MACK TRUCKS, INC.
P.O. BOX 26115
Greensboro, NC 27402-6115

SUBJECT: Vehicle Safety Recall - SC0342
Headlight Switch

Headlight Rocker Switch Failure

SC0342, Headlight Rocker Switch Failure

Figure 2 — Disconnect 6Pin Connector

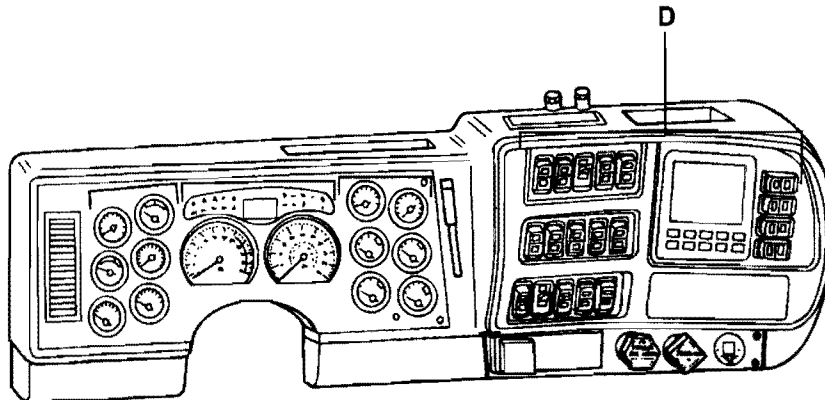
3. Disconnect the 6-pin D-panel connector.

4. Connect the headlight jumper harness (part No. 41MR41165M) between the cab 6-pin cab-to-D-panel harness connectors.
5. Install the relays (part No. 25171095) into the relay sockets of the harness legs labeled "Head Lamp Relay" and "Marker Relay."
6. Using self-tapping screws, secure the two relays to an accessible location on the cab bulkhead behind the instrument panel.
7. Secure the jumper harness ring terminal to the cab ground stud located behind the ABC (gauge cluster)-panel.

Figure 4 — Disconnect 4-Pin and 30-Pin Connectors

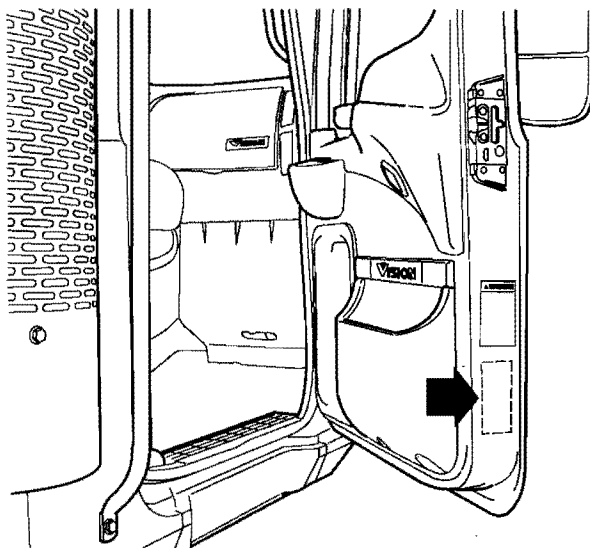
3. Disconnect both the 4-pin and 30-pin D-panel connectors.

4. Install the headlight jumper harness (part No. 41MR4166M) between the 30-pin chassis-to-D-panel harness connectors and between the 4-pin chassis-to-D-panel harness connectors.
5. Install the relays (part No. 25171095) into the relay sockets of the harness legs labeled "Head Lamp Relay" and "Marker Relay."
6. Using self-tapping screws, secure the two relays to an accessible location on the cab bulkhead behind the instrument panel.
7. Reinstall the D-panel.
8. Reconnect the batteries by connecting the positive battery cable(s) first, and then the negative cable(s).
